Bridgeton SLF
Permit 118912
St. Louis County
Enforcement

**Revised Modification to the Gas Monitoring Probe Network
Bridgeton Landfill, LLC – Permit No. 118912**

**Re: Revised Gas Monitoring Probe Permit Modification
Bridgeton Landfill, Solid Waste Permit 118912
St Louis County Operating Permit 0418**

**PROPOSED LFG MONITORING PROBES
BRIDGETON LANDFILL**

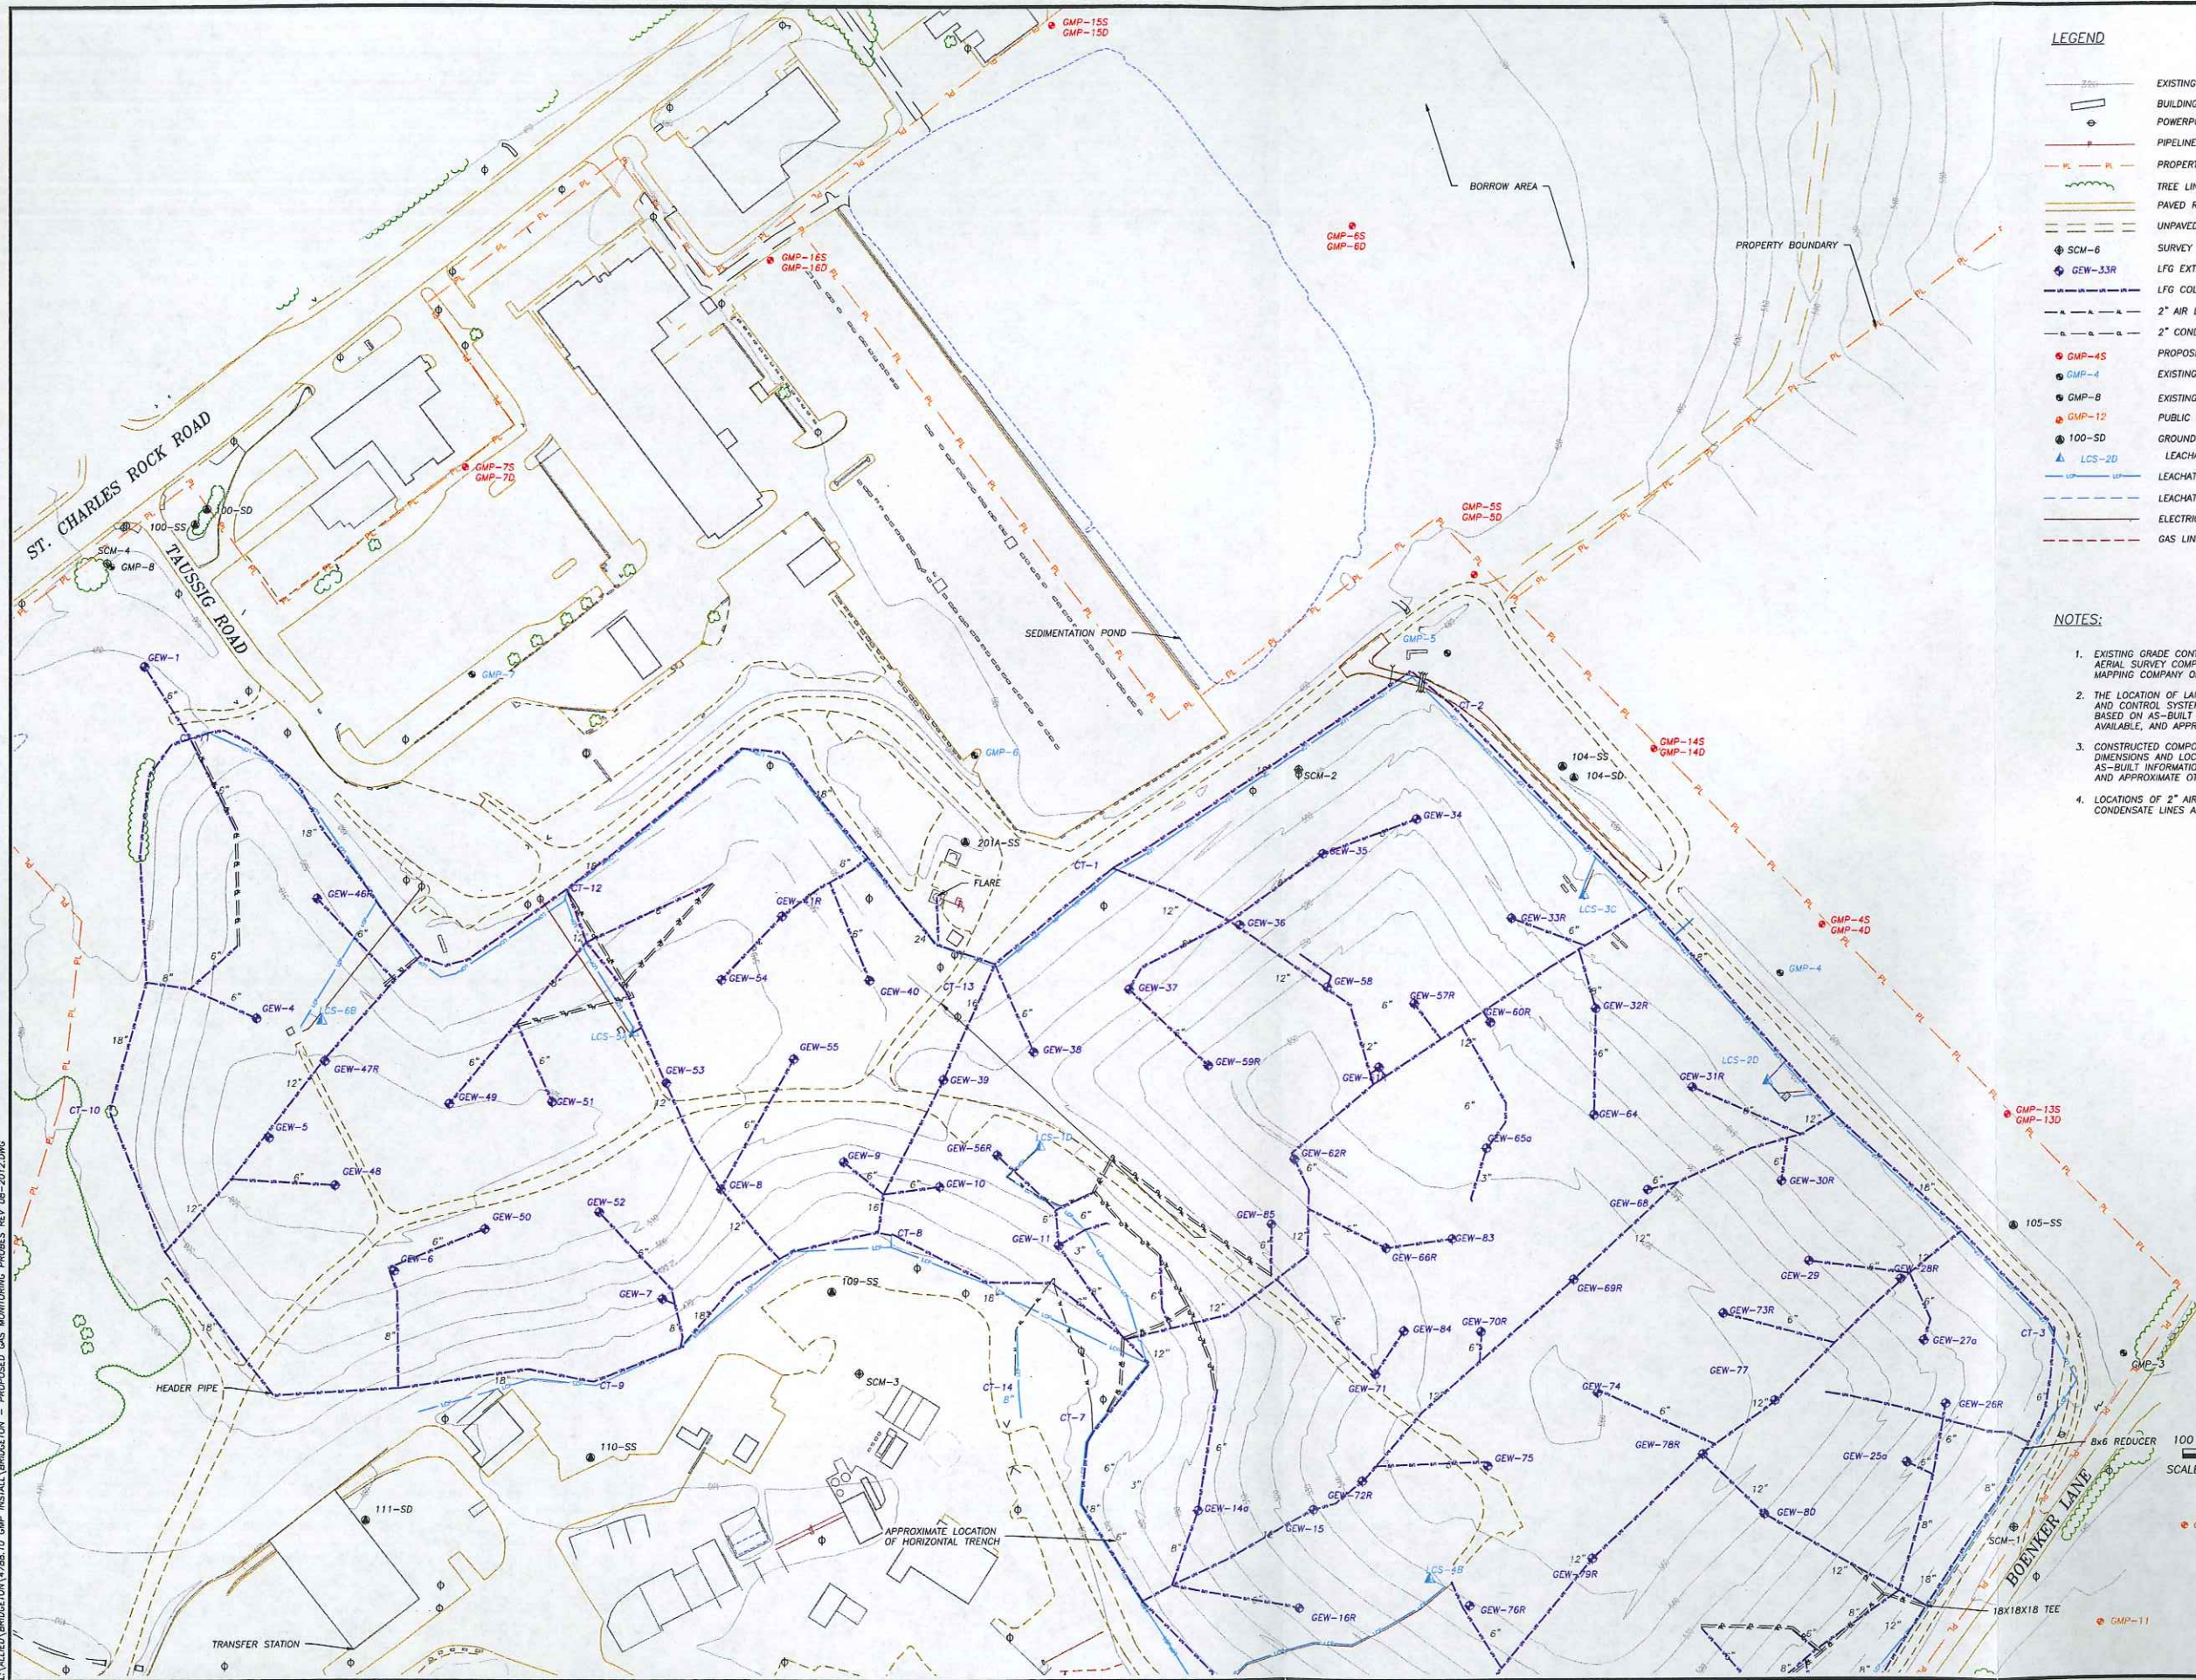
With establishing the permitted property boundary farther to the east, the Bridgeton Landfill requests to relocate the GMPs in this area of the landfill to the proposed compliance boundary which is at the property boundary. The location and spacing of these GMPs were determined based on guidance outlined in the SWMP's May 2012 draft Methane Gas Policy. Attachment A includes a site layout showing the existing monitoring network as well as the proposed GMPs. A total of eight additional GMPs are proposed for installation including the replacement of four existing GMPs (GMP-4, GMP-5, GMP-6 and GMP-7), as well as four new GMPs (GMP-13, GMP-14, GMP-15, and GMP-16). The new GMPs will be nested probes and use the following designations: GMP-4D, GMP-4S, GMP-5D, GMP-5S, GMP-6D, GMP-6S, GMP-7D, GMP-7S, GMP-13D, GMP-13S, GMP-14D, GMP-14S, GMP-15D, GMP-15S, GMP-16D, and GMP-16S.

GMPs slated for replacement (GMP-4, GMP-5, GMP-6 and GMP-7) will be relocated adjacent to the property boundary. The replacement GMPs (GMP-4D, GMP-4S, GMP-5D, GMP-5S, GMP-6D, GMP-6S, GMP-7D, and GMP-7S), as well as the new probes, GMP-13D, GMP-13S, GMP-14D, and GMP-14S, will be located in the vicinity of the existing impacted GMPs (GMP-4, GMP-5, GMP-6, and GMP-7) and will be nested to monitor the unconsolidated soil zone and the bedrock zone to assess if migration is occurring at the property line and potentially the particular zone migration is occurring.

Replacement GMPs, GMP-4 nested and GMP-5 nested, will be installed in the vicinity of existing GMP-4 and GMP-5 approximately 5 feet off of the property boundary as recommended by the SWMP. Replacement GMP-6 nested will be located in the borrow area. Additionally, to maintain an approximate 500 foot or less spacing between GMPs in accordance with MDNR's SWMP regulations 10 CSR 80-3.010(14)C, four new GMPs (GMP-13 nested, GMP-14 nested, GMP-15 nested and GMP-16 nested) will be installed. GMP-13 nested will be installed adjacent to the property boundary between existing GMP-3 and proposed GMP-4 nested, and GMP-14 nested will be installed adjacent to the property boundary between proposed GMP-4 nested and proposed GMP-5 nested, as recommended by the SWMP. GMP-15 nested will be installed east of the sedimentation pond and GMP-16 nested will be installed near the property boundary on the northeast side of the hauling company parking lot. GMP-13 nested and GMP-14 nested are additional GMPs proposed along the southeast property boundary to maintain spacing no greater than 500 feet between monitoring probes.

The deep probes (D) will be screened within bedrock with a termination depth approximately 10 feet below the historic groundwater table or 10 feet into the bedrock, whichever is deeper. The shallow probes (S) will be installed to the top of bedrock determined during drilling. Drawing 1 illustrates the proposed locations of the GMPs. The eight locations of the proposed GMPs (replacement GMP-4 nested, replacement GMP-5 nested, replacement GMP-6 nested, replacement GMP-7 nested, GMP-13 nested, GMP-14 nested, GMP-15 nested, and GMP-16 nested) are at a spacing no greater than 500 feet, which is in accordance with the maximum spacing listed in 10 CSR 80-3.010(14)C.
